| Document Title: | Sentinel Black Start Petition to Amend Revision 1 - Black Start Upgrade |

Petition to Amend
Sentinel Energy Center
(07-AFC-3)
Black Start Upgrade
Revision 1

Submitted to: California Energy Commission

Submitted by: Sentinel Energy Center, LLC

7.2 Battery Site Plan

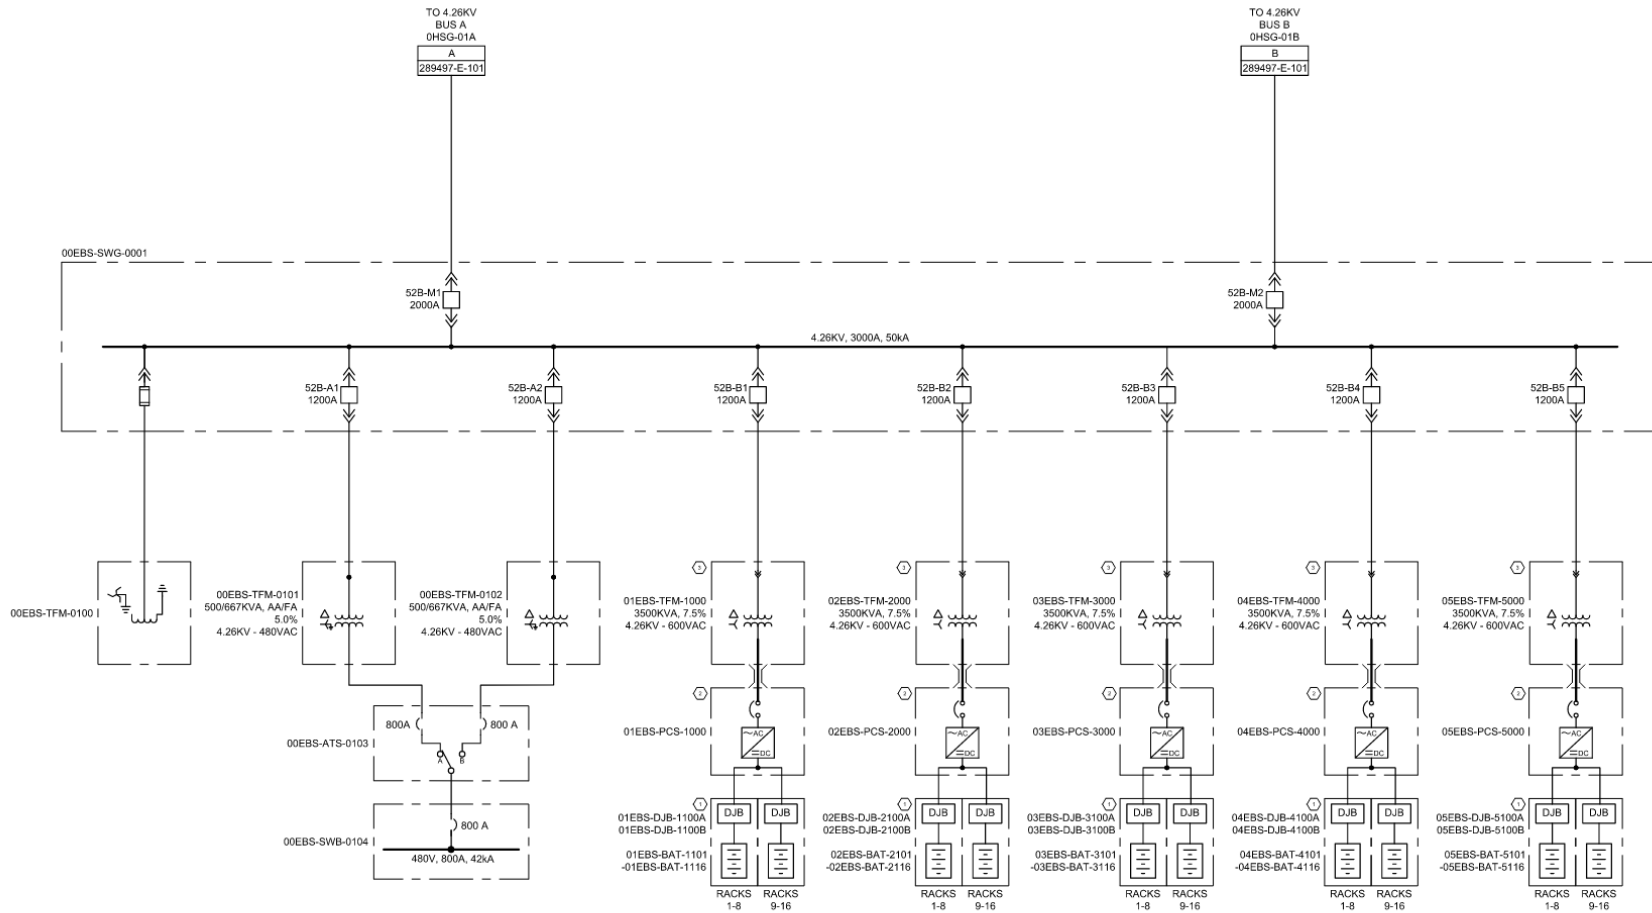
New in-ground cable trench will be constructed as shown on Figure 7.2. Excavating equipment and excavating hauling equipment will be utilized to place the cable trench. BESS Underground conduit will be placed in the correct lifts as the backfill is being brought up to elevation.
